**LIMA TOWNSHIP PLANNING COMMISSION**  
**P.O. BOX 59, CHELSEA, MI 48118**  
**AGENDA**  
**MONDAY, MARCH 25, 2024 – 7:00 P.M.**

## **Site Plan Review For Lima Township, Michigan**

Re: St. Vladimir Russian Orthodox Church  
Preliminary Site Plan Review  
Plan Date: February 28, 2024

## Site Plan Review For Lima Township, Michigan

01 PROPOSED SITE PLAN  
T1 SCALE: 1" = 20'-0"

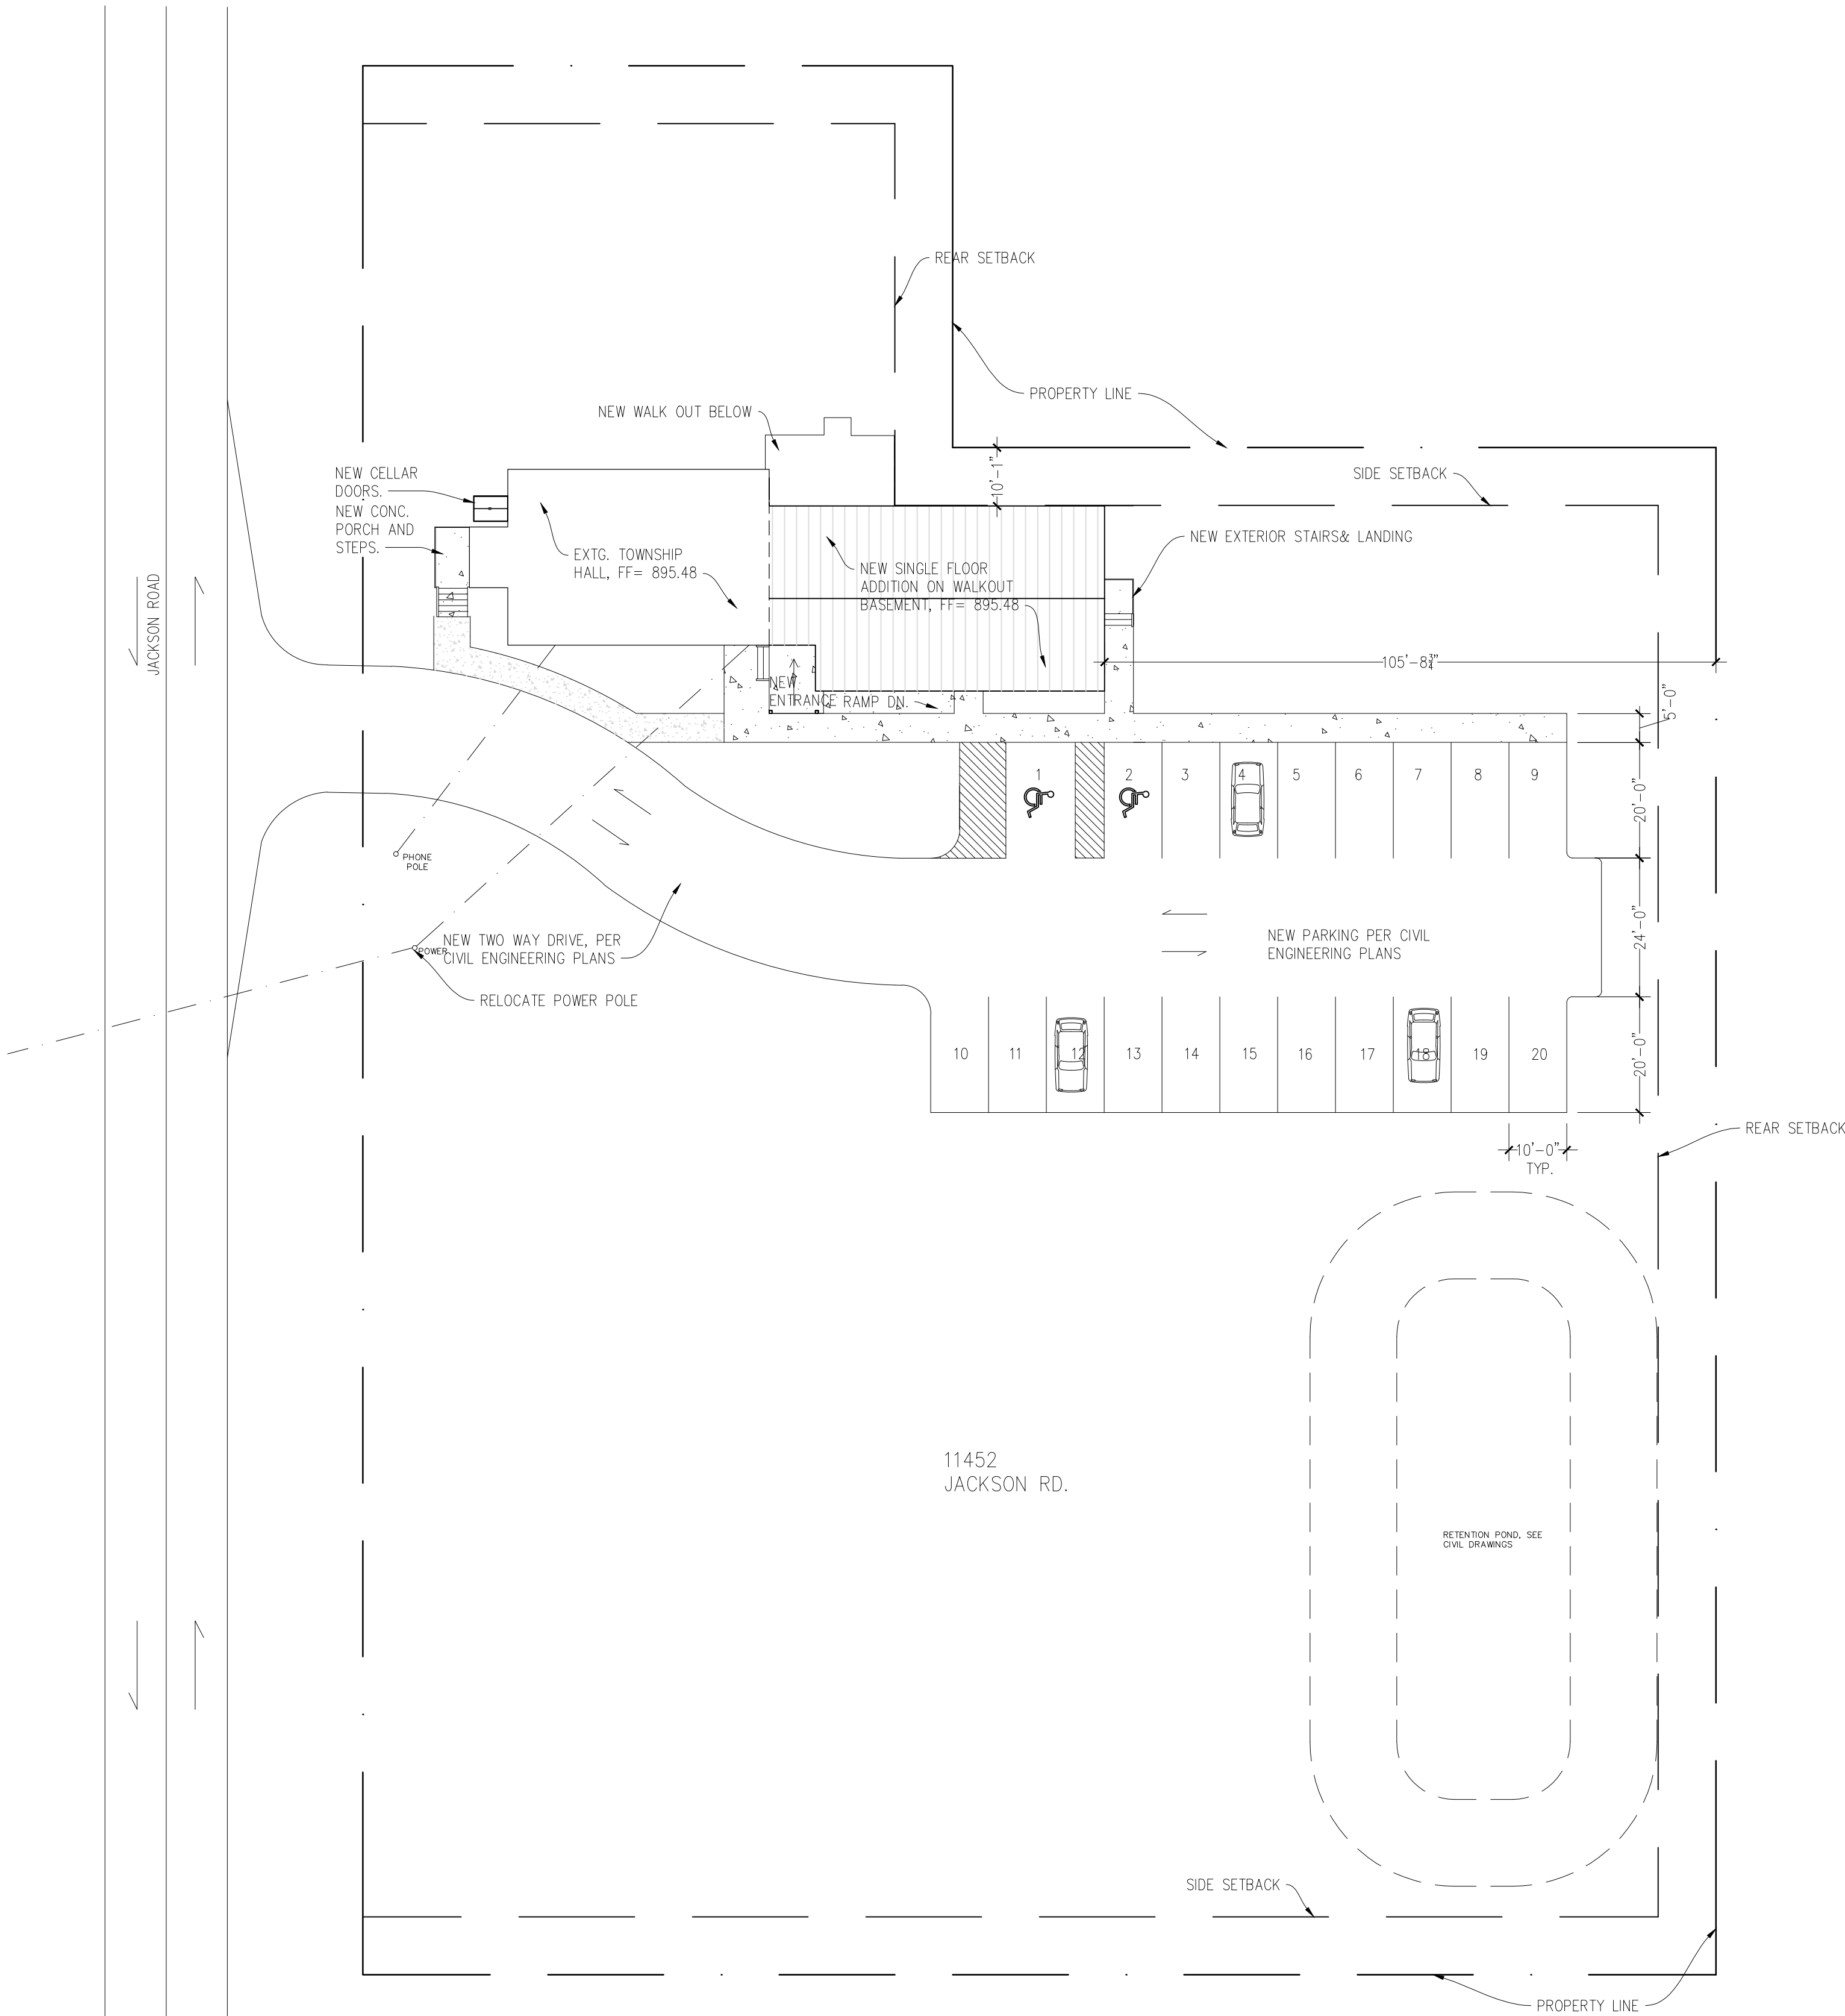
Township Hall projects into the front yard setback by over thirty-one and a half (31'6-3/4") feet, according to the table on Sheet T1. The front setback line should be depicted on the site plan. The building was in place prior to the current zoning regulations, making the building legally nonconforming. It is unclear if this front setback distance is measured from the building or the porch/ramp structure. It appears that the dimensions of the proposed porch project into the setback less than the existing porch, but this should be clarified by on the plan, as Sheet T1 indicates that the projection into the front yard setback is proposed to stay the same. Dimensions of both the existing and new porch/ramp area are required to determine how the setback projection is changing and if a variance is required.

***Items to be Addressed:*** (1) Combine the two plan sets for the final site plan submittal. (2) Depict the front setback on the site plan. (3) Applicant shall provide dimensions of existing and proposed porch/ramp area. (4) Applicant shall indicate where on the structure the setback distance is measured from.

01 PROPOSED SOUTH ELEVATION  
A5 SCALE: 3/16" = 1'-0"

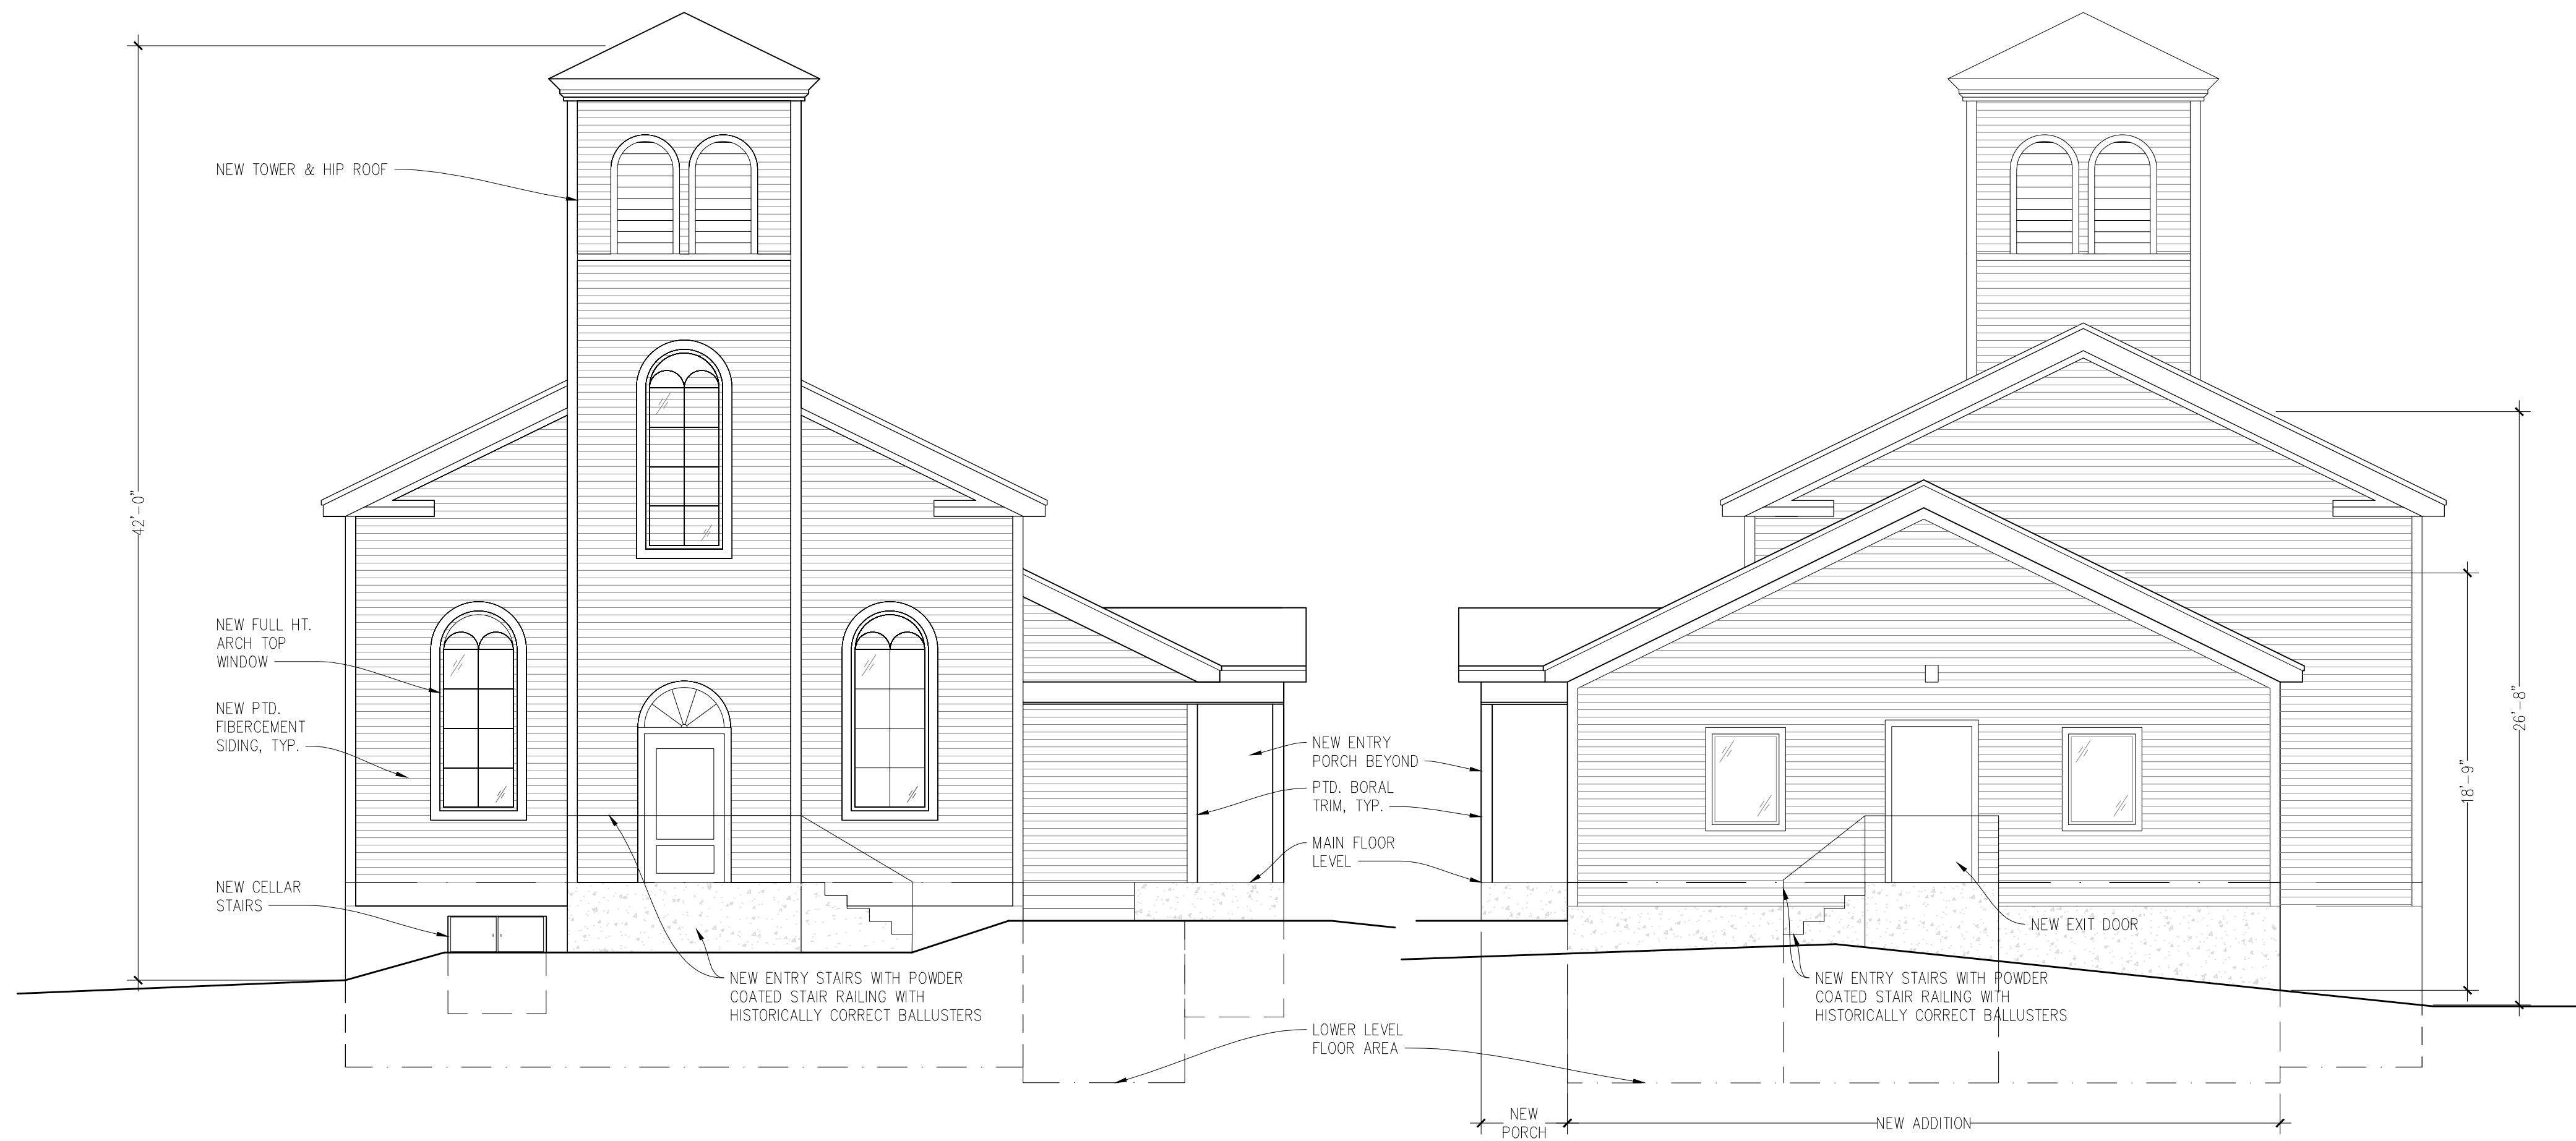
The plan also proposes the replacement of the existing siding. The colors are not provided. New window treatments are indicated on the south elevation, modeled after historic window character and shape. The window treatments on the north building addition appear to be more modern. The existing chimney on the west elevation will be removed. On the south elevation, above the primary building entrance, a tall tower is proposed, with historic-looking arches and roof shingles to match the existing roof shingles.
